ARCHITECTURAL REVIEW BOARD STAFF REPORT

Project #/Name	SP-2024-19: UVA CCU PWSF
Review Type	Advisory Review for a Tier III Personal Wireless Services Facility
Parcel Identification	07600-00-00-05500
Location	1201 5 th Street (Fig. 1)
Zoned	Highway Commercial (HC) / Entrance Corridor (EC)
Owner/Applicant	University of Virginia Community Credit Union Inc. / Williams Mullen (Valerie Long)
Magisterial District	Scottsville
Proposal	To construct a new 165'-tall monopole tower approximately 400' to the northeast of the existing 155.5' tower on the same parcel, and to construct related features including an enclosed lease area at the base of the tower and associated equipment. The existing tower will be removed.
Context	The site is located north of I64 and west of 5 th St. A mix of commercial development is located along 5 th St. north of the interchange. Residential developments are to the northwest and south of the Interstate. Gardens and parkland are to the west. An existing telecommunications facility stands just west of the existing building.

ARB Meeting Date	September 16, 2024
Staff Contact	Margaret Maliszewski

Fig. 3: Purple highlight identifies approximate areas of visibility of the balloon from the Entrance Corridors.

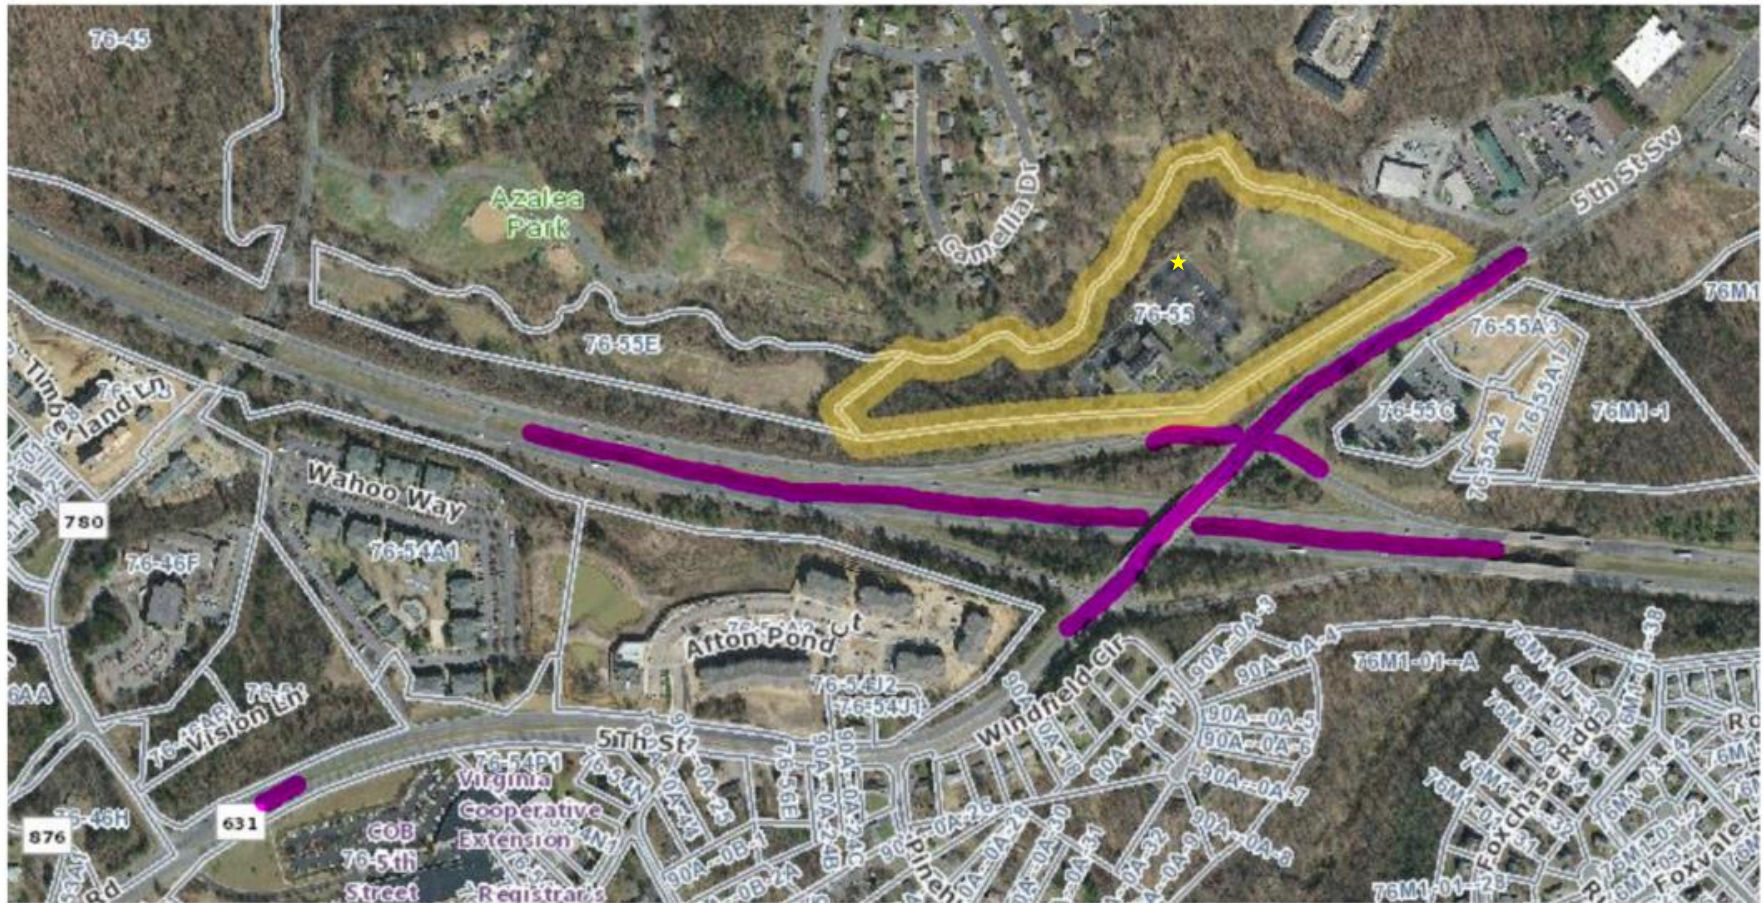
If constructed as proposed, visibility and the visual impact of the monopole are expected to be similar to that of the existing facility. The proposed monopole is expected to be somewhat less visible from the I64 corridor and somewhat more visible from the 5th St. corridor than the existing pole. (Fig. 3)

During the balloon test, the balloon was intermittently visible from I64 from approximately the vicinity of Azalea Park (Fig. 4) west of the interchange to the on/off ramps east of the interchange. When the balloon was visible, it was skylit and well above the trees.

On 5th St. the balloon was visible in the vicinity of the County Office Building at 5th St. (Fig. 5) It was also visible approaching the interchange and, on the overpass, traveling northbound. (Fig. 6) The balloon was visible southbound on 5th St. from the city/county line and the site entrance. (Fig. 7) It was visible from both ramps on the north side of the Interstate. (Fig. 8) In these locations, the balloon was skylit and flying well above the trees. The balloon was also minimally visible through the trees in the right-of-way, from the site entrance to the ramps on 5th St. (Fig. 2)

The ARB finds that the proposed location of the facility is expected to result in similar visual impacts as are produced by the existing facility. No additional negative impacts on the general character of the area are expected.
